January 15, 2025

**Re: Closure Request
JR Oil, Ltd. Co.
Eaton B AC 1#001
Unit Letter G, Section 12, Township 25 South, Range 37 East
Lea County, New Mexico
Incident ID# NOY1704032211
1RP-4591**

Figure 1 Sample Location Map

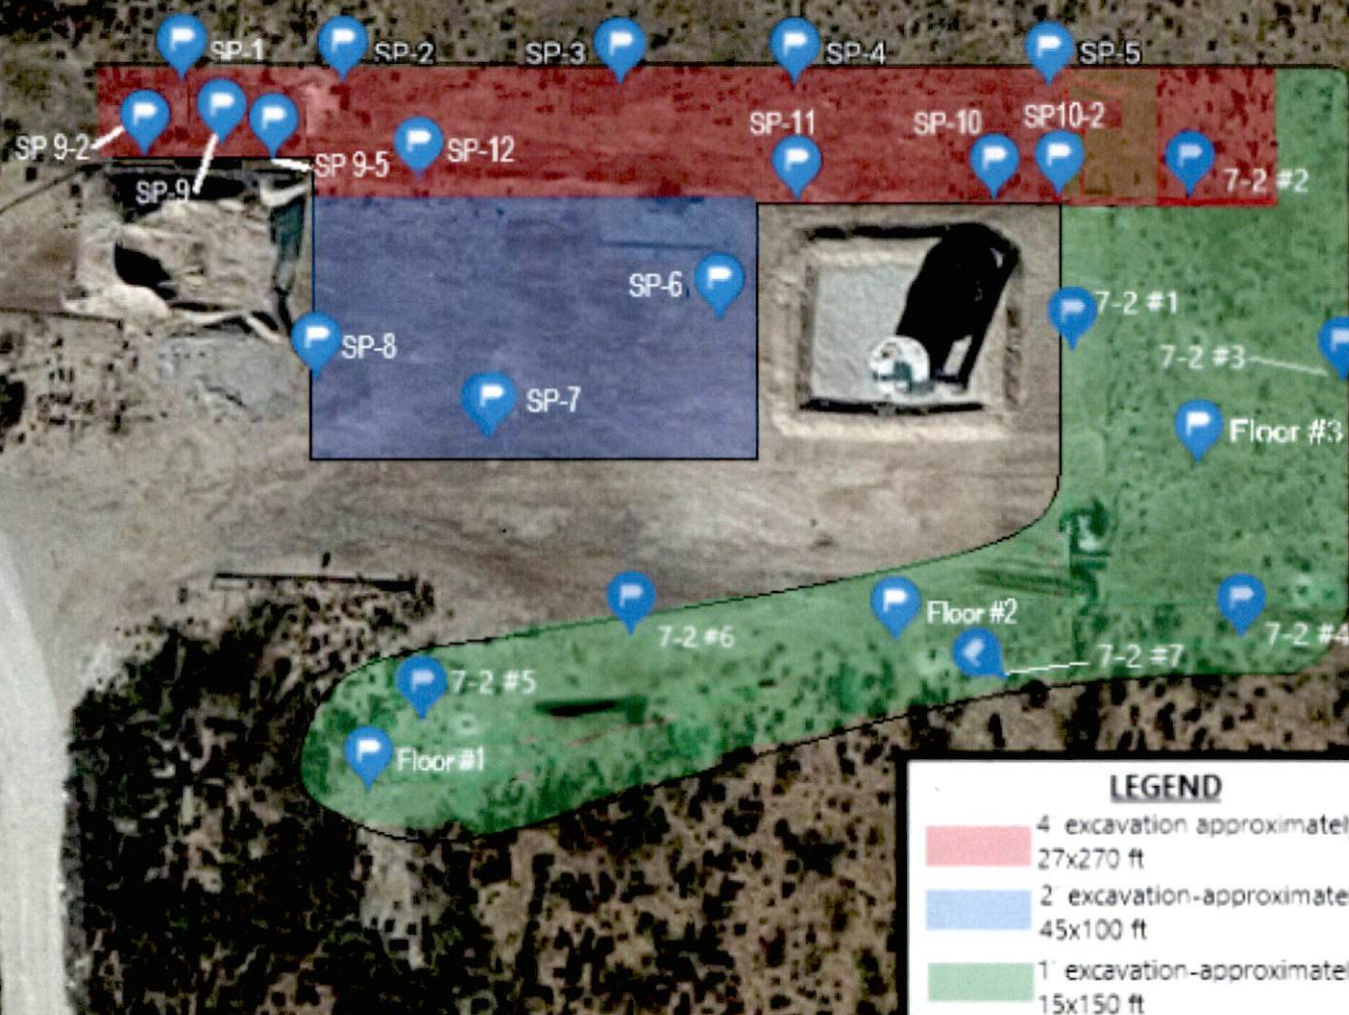
1. There may have been some miscommunication during the meeting on February 27, 2018. Please be advised that generally, confirmation sidewall samples are required for each area with a different excavation depth. For example, sidewall/edge samples were expected at the border between the 4 ft. (red) and 2 ft. (blue) areas and the border between the 4 ft. and 1 ft. (green) area. Do you have field tests to represent the change in excavation depth with permissible levels of BTEX, chlorides, and TPH extended demonstrated?

2. Were confirmation samples taken from the edge of the 1 ft. excavation (green)?
3. Does delineation sample location SP-9 fall within the 4 ft. or 2 ft. excavation area?

4. A bottom confirmation sample will be required at 2 ft. bgs for the area represented by delineation sample location SP-5. Laboratory analyses of TPH extended and chlorides are required.

5. What is the pile South of SP-9 area? Is this stockpiled soil?
6. Was impacted soil removed and area lined before the reestablishment of the battery? It is situated over delineation sample point SP-4, which had elevated BTEX and TPH extended up to a 1 ft. in depth and above permissible chloride levels at 11 ft. bgs. If not, this would explain the above permissible chloride levels for sidewall samples SP-10 and SP-12. Were confirmation bottom and sidewall samples taken for this area around the bermed tank battery?

These additional confirmation samples will be taken in the 1 ft. excavation area. See attachment. Please review.

- 1. Confirmation sidewall sample to represent SP-4 delineation sample location will be analyzed for BTEX, TPH, and chlorides.*
- 2. Confirmation sidewall samples will be taken for chloride analyses at the East border and North and South of the pasture area.*
- 3. A bottom confirmation sample will be taken for chloride analyses in the vicinity of the Floor 1 area.*
- 3. Confirmation sidewall sample for TPH extended analyses will be taken in the area represented by the SP-8 delineation sample location."*

Updated To Reflect Required action from 6-29/2018 meeting
